Video Products  
Service Bulletin

Model: SLV-353UC/555UC/757UC

No.108

Subject: RKB Cam Gear Alignment Correction Date: February 12, 1990

Fig. 3-31.

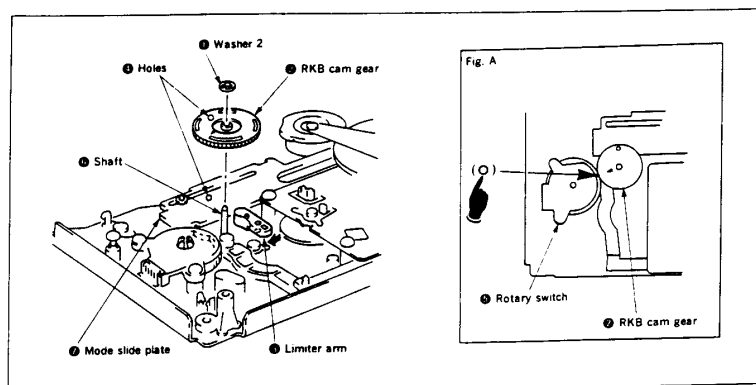
Please correct paragraph 3-25 on page 19 of the VHS Adjustment Manual II to read as follows:

Solution: 3-25. RKB CAM GEAR (Fig. 3-31)

- 1) Remove the adjuster arm ass'y. (Refer to 3-22.)
  - 2) Remove washer 2 ①, then pull out the RKB cam gear ②.
- [Precautions on remounting] (EJECT MODE)
- When the limiter arm ③ is pushed in the direction of the arrow, the pin must fit into the notch on the RKB cam gear ②.
  - The ○ mark on rotary switch ④ must match up with the ◀ mark on the RKB cam gear ② as shown in Fig. A.
  - Apply 1/2 drop of lubricant to shaft ⑤.
  - Match up the holes ⑥ on the RKB cam gear ② and the mode slide plate.
